# CERTIFICATE OF APPROPRIATENESS PLACARD

Changes to previously approved COA (COA-0005-2023), including: shift mudroom north wall, breezeway columns, and wood privacy screen; shorten breezeway eave; enclose west soffit; enlarge north addition window; alter and shift west door; remove east picture window; relocate east door; relocate chimney; relocate mechanical equipment; widen driveway; install front yard fence

525 Watauga St

COA-0123-2023

# SITE PLAN - PROPOSED

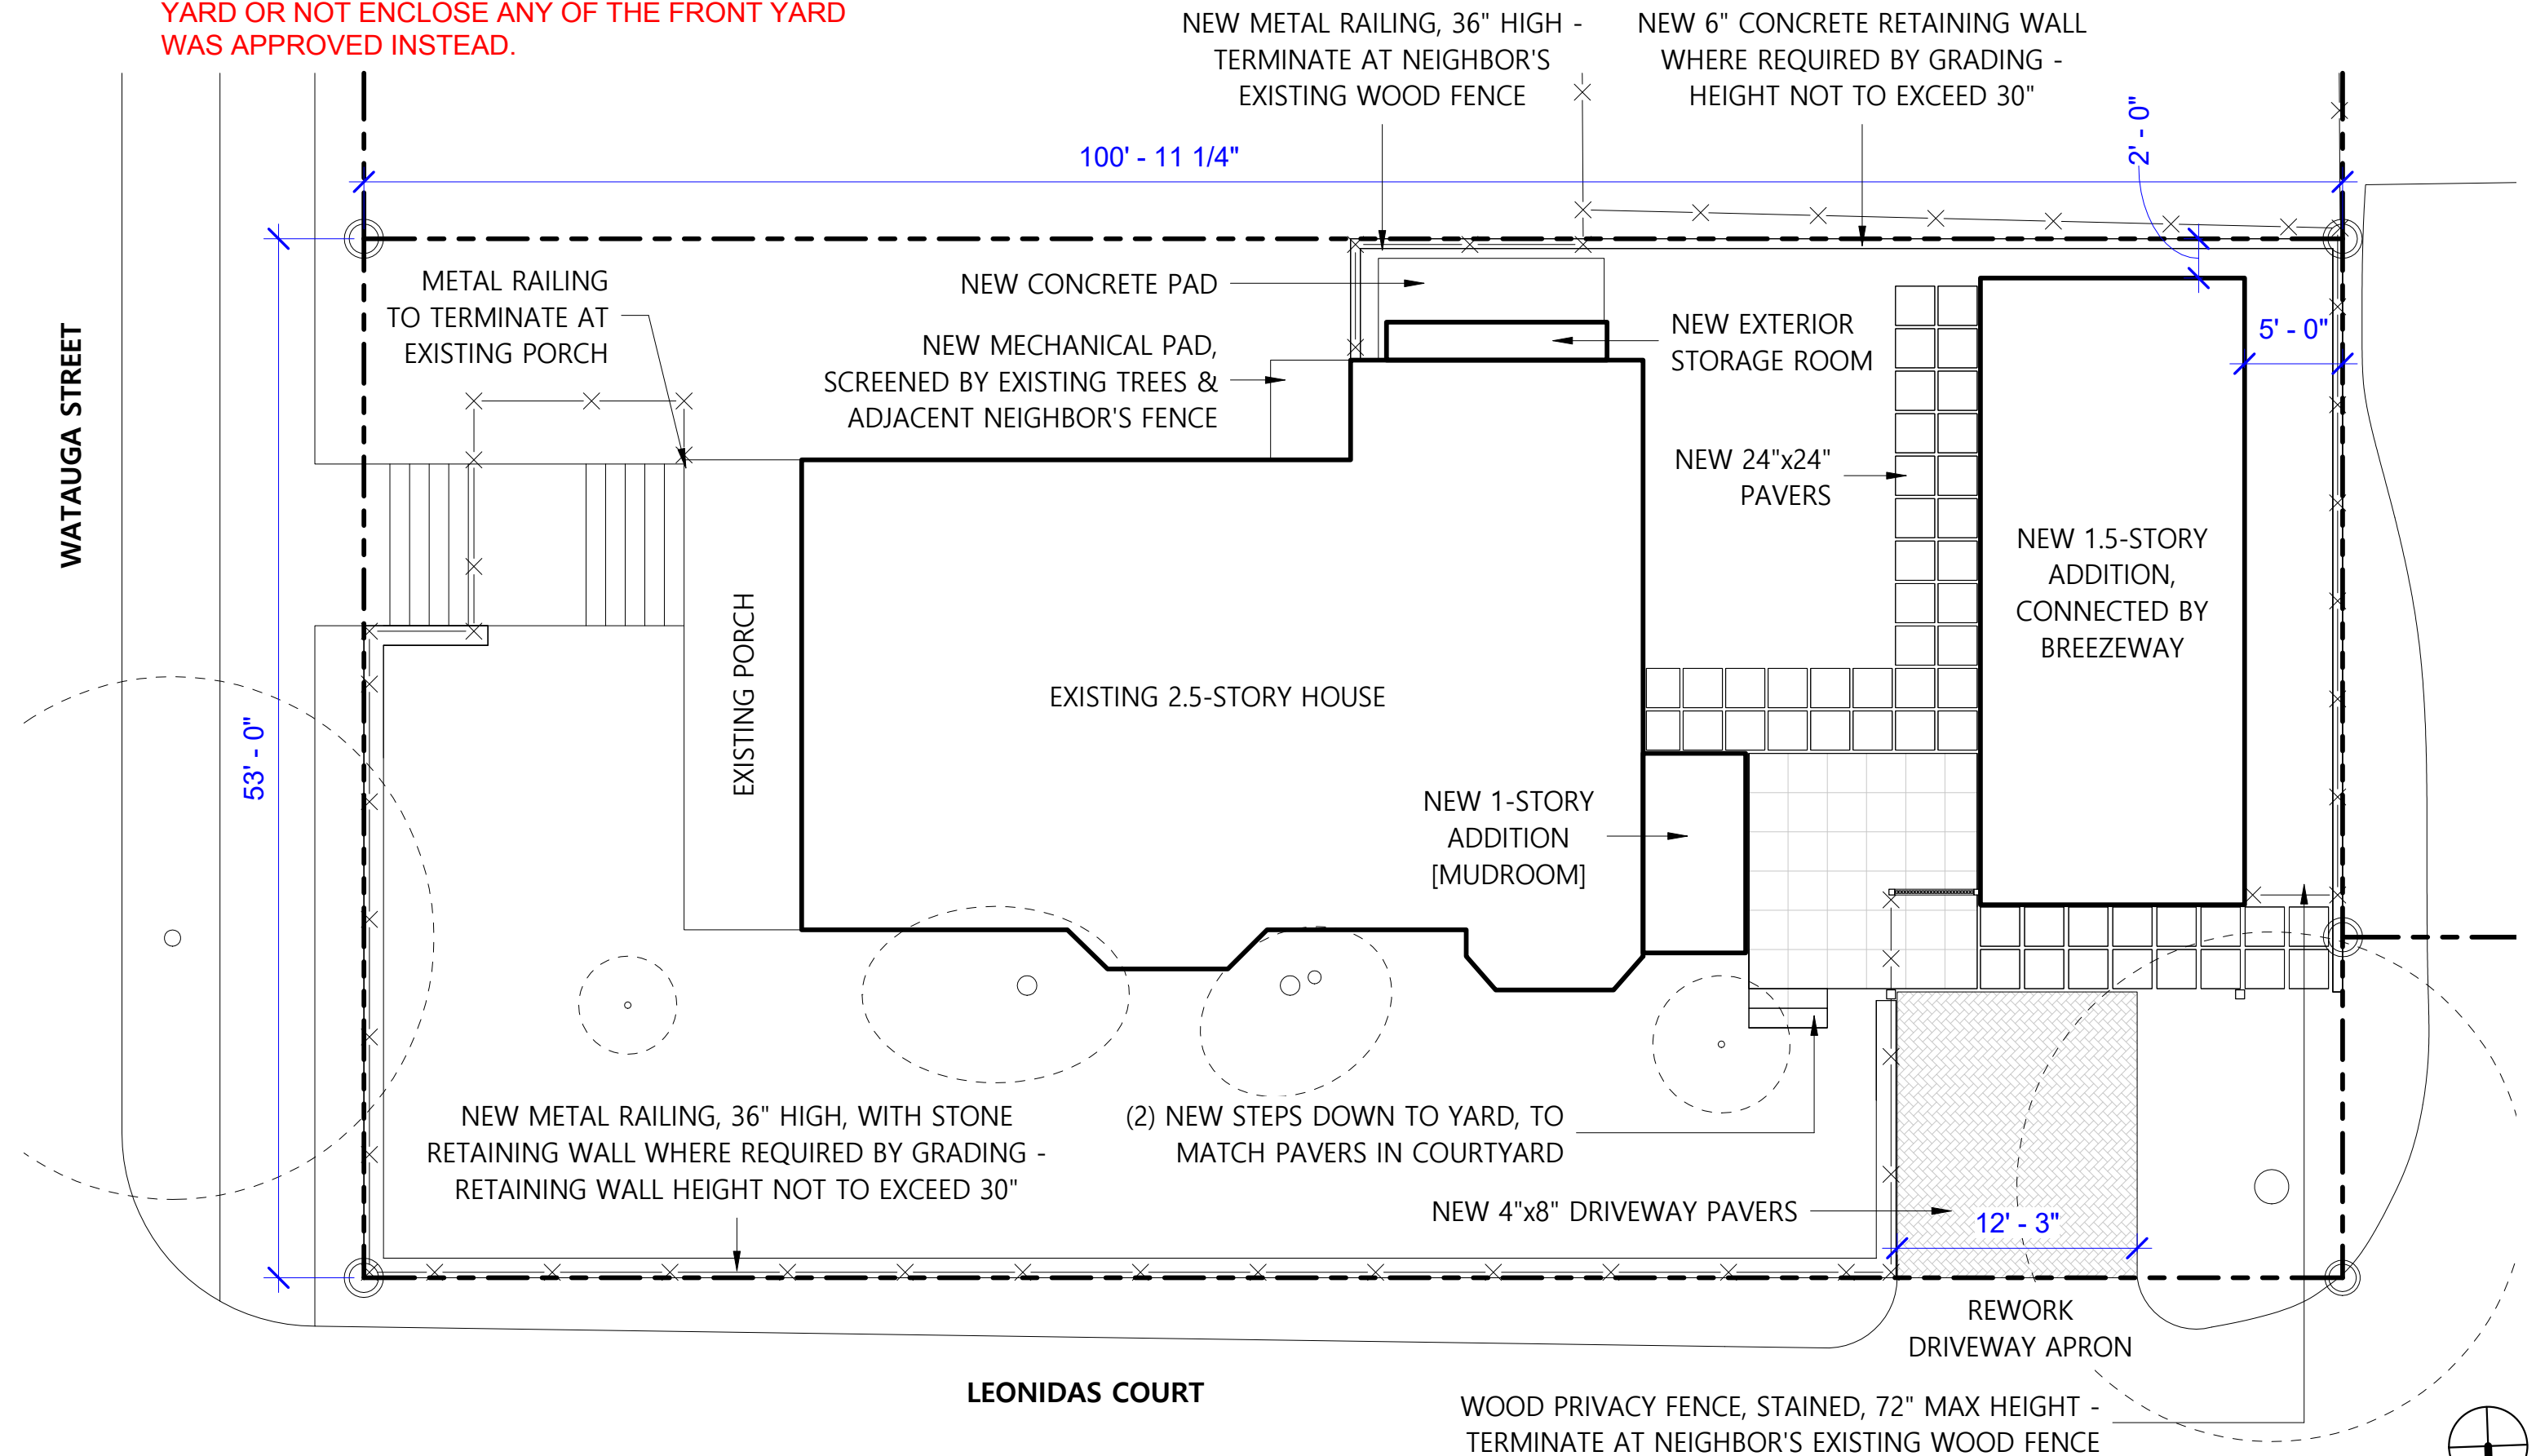
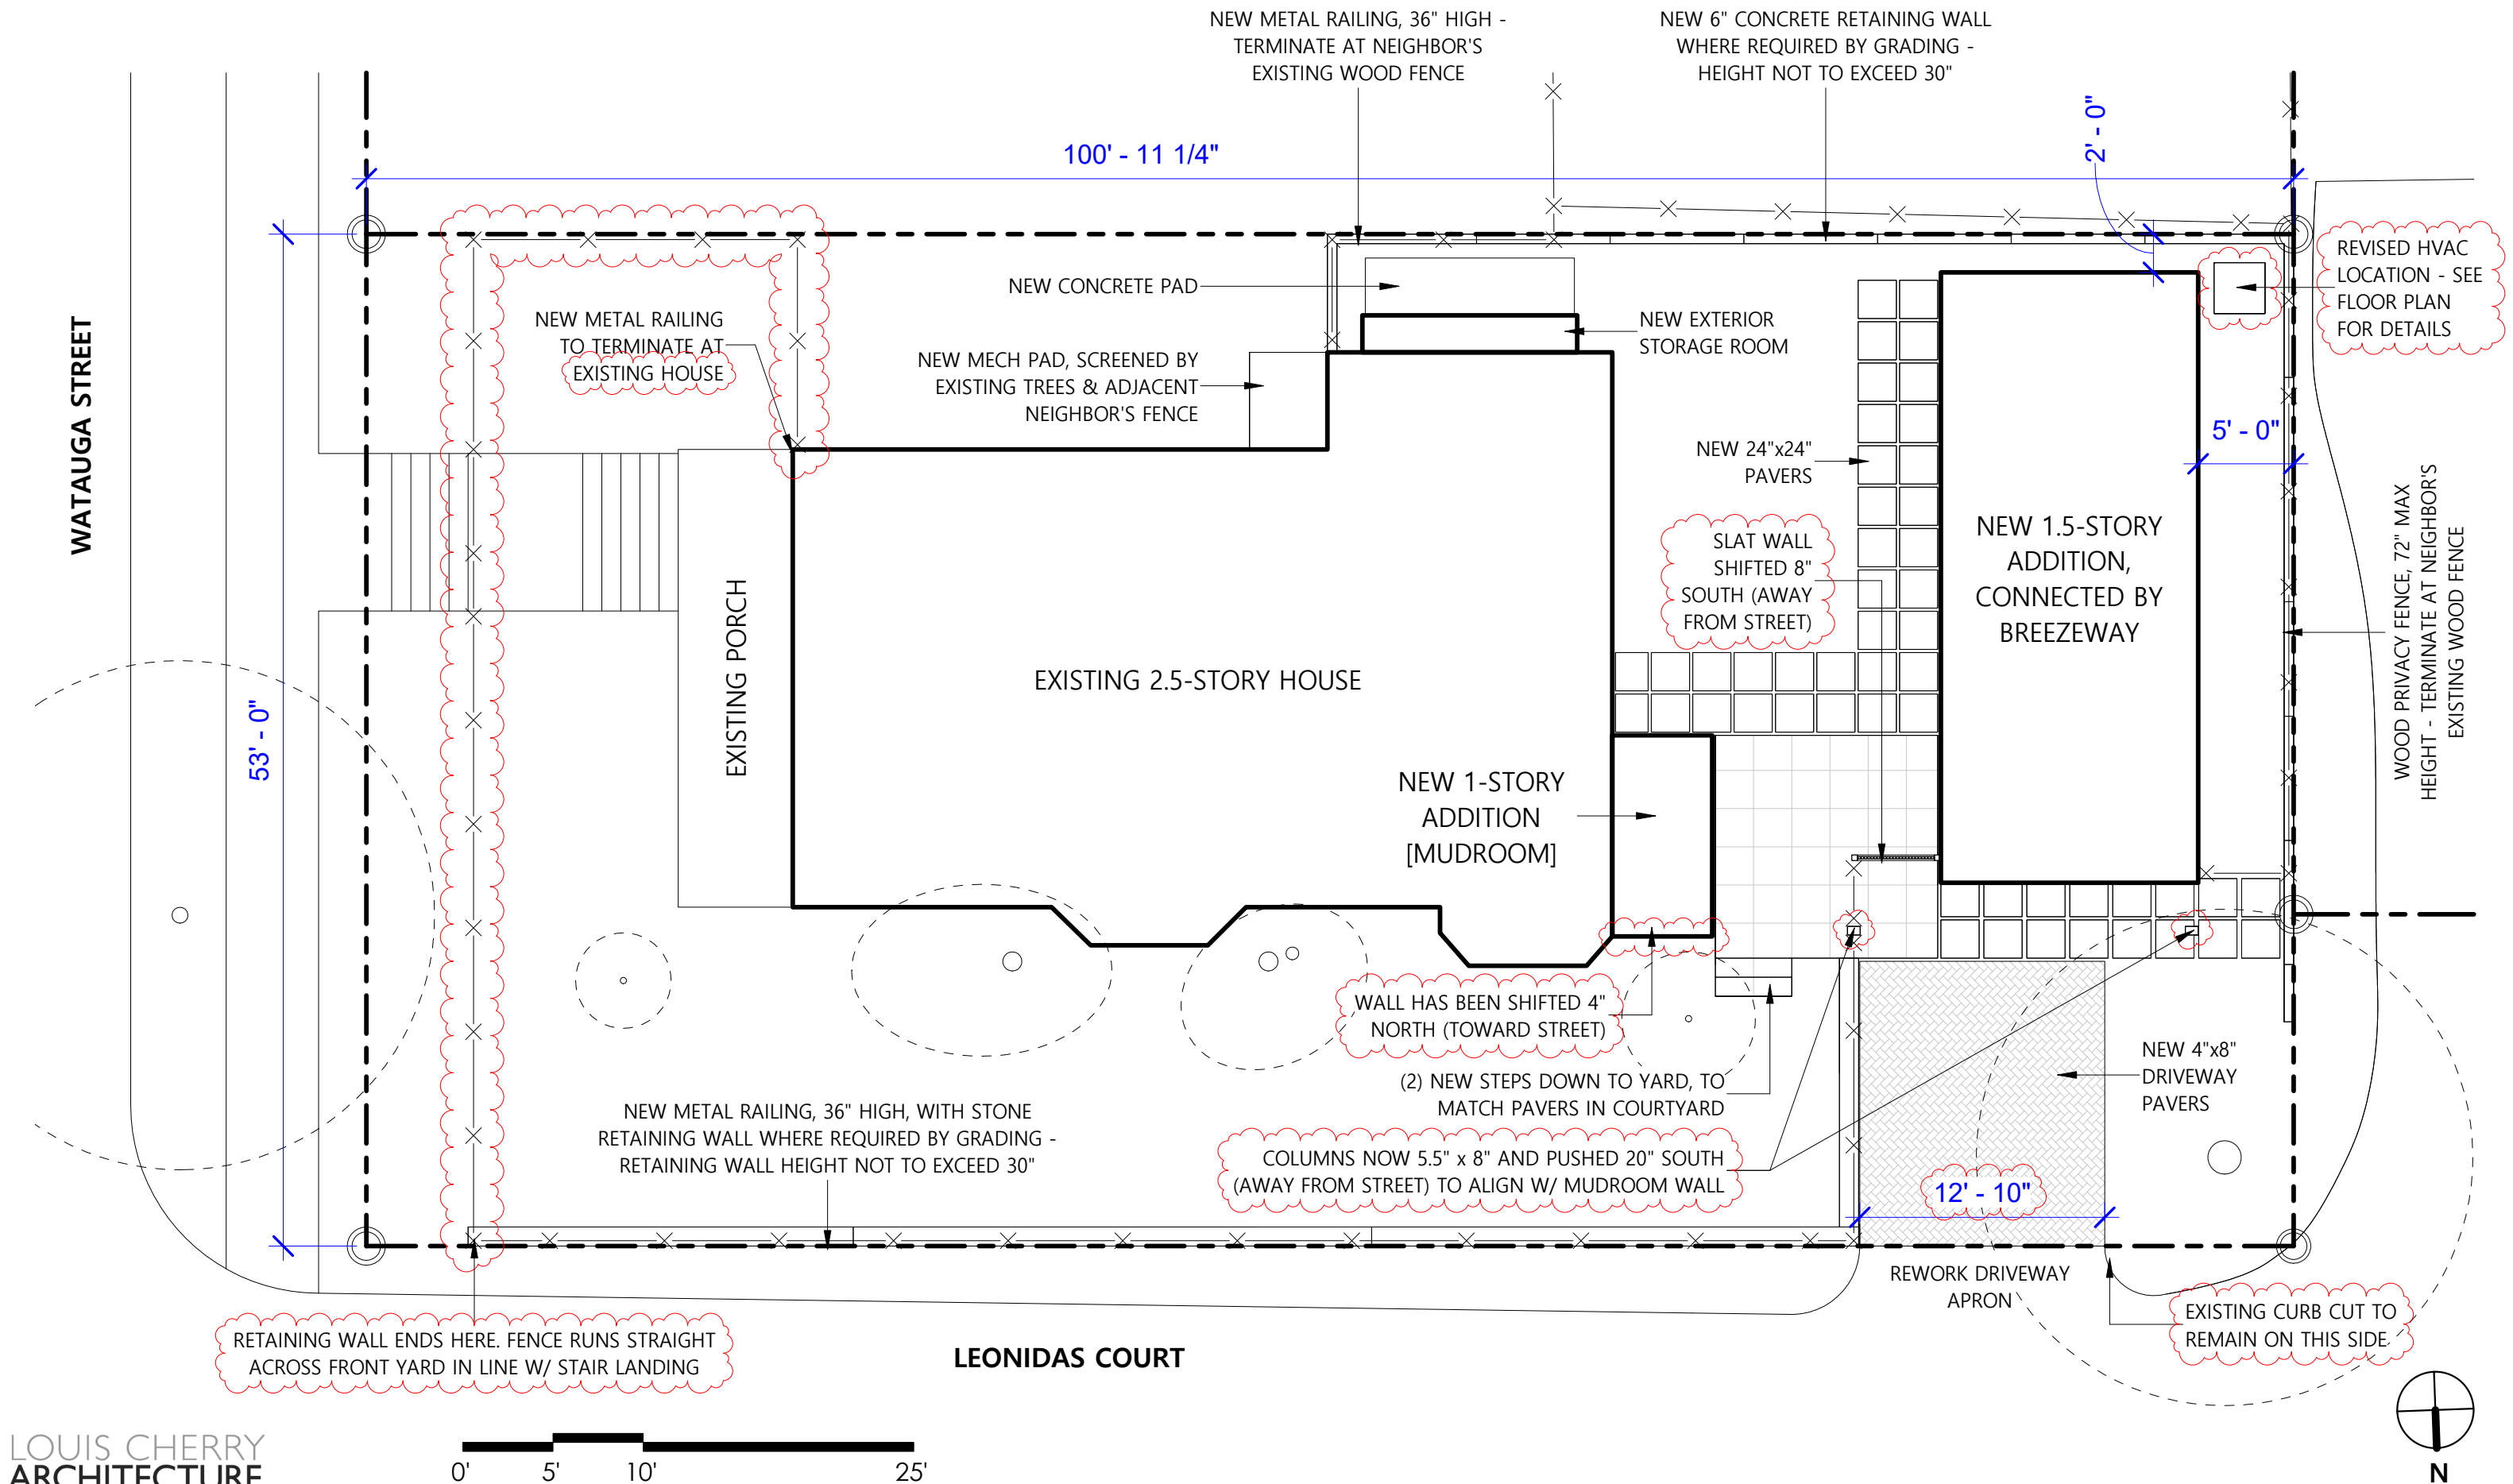
- The W edge of the driveway has been shifted 7" W so that this edge of the curb and drive remains in the same location as the existing curb/driveway. As we shifted the plan during the COA iterations we didn't realize how close we landed back to existing. This results in a driveway that is 12'-10" instead of the approved 12'-3". Detail best viewed on pages 4 and 5 (approved vs. proposed site plans).

Dashed line shows existing edge of driveway. As we shifted the plans during the major COA application we didn't realize how close we landed to existing again. We would like to maintain the curb cut and edge location on this side to minimize demolishing/rebuilding in almost the same place.
